ENGINEER'S DAILY REPORT

04-SF-80-13.2/13.9
Contract No. 04-0120F4
{SAS Superstructure}

Project Description: SAS SFOBB Project

**SUBJECT: Prototype Fixture with three types of access (No remote ballast included)
Submitted for review and comments.**

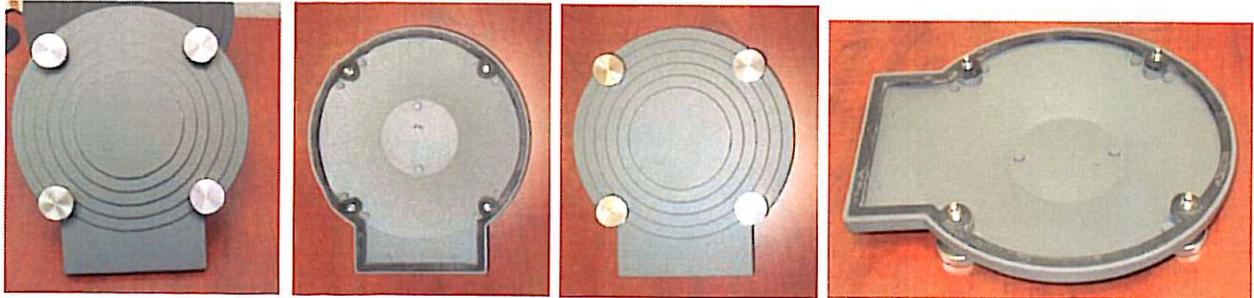
- **General Fixture Comments:**
 - Fixture housing is heavy duty and looks capable of withstanding the elements at the locations indicated in the contract.

- Due to the weight of the fixture and the attachment to the cable stanchions the adjustable mounting brackets need to be capable of supporting the fixtures. This needs to be verified.

- Since the remote ballast was not submitted with the fixture it needs to be compatible to the mounting location shown on the plans and properly interconnected to the fixture housing. I do not believe the ballast box should be part of the mounting support of the fixture.

- Since there are two types of mounting requirements for the fixtures (Up-lighting & Down-Lighting) the accessibility for re-lamping will be different at these two locations. The up-lighting fixture should be re-lamped from the removable lens end of the fixture. The down-lighting needs to be re-lamped from the rear access of the fixture.

- Fixtures are required to be UL listed for use in wet locations.

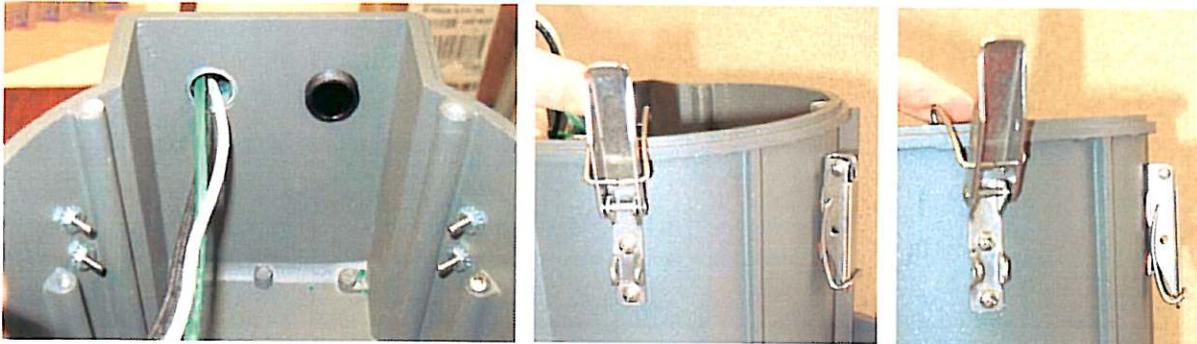
- Knurled knob access plate comments with handle/lanyard attachment.
 - This looks like the standard type of closure for the fixture with the addition of the handle/ lanyard support and attachment of the lamp base to the inside surface.
 - Concern about the hole through the plate to connect the handle to the lamp support bracket. There does not seem to be properly sealing to prevent moisture from entering the housing.
 - Concern about how the mounting bracket for the lamp socket is attached. Vibration or use of the handle could cause the securing hardware to work loose.
 - This would be the best type of access plate provided the concerns can be addressed and resolved. Mounting the internal bracket separate from the external handle.

- Latches only access plate comments with handle/lanyard attachment.
 - The holes for the knurled knob bolt are plugged. This could be a possible problem for future leakage into the housing.
 - The latching bracket is not sealed tight enough to prevent moisture from entering the housing. The ridges on the back plate prevent a positive seal.
 - The attachment of the handle and the support bracket of the lamp socket do not seem to be secure enough to prevent loosening of the bracket or handle.
 - I do not recommend this type of attachment of the rear plate to the fixture housing.
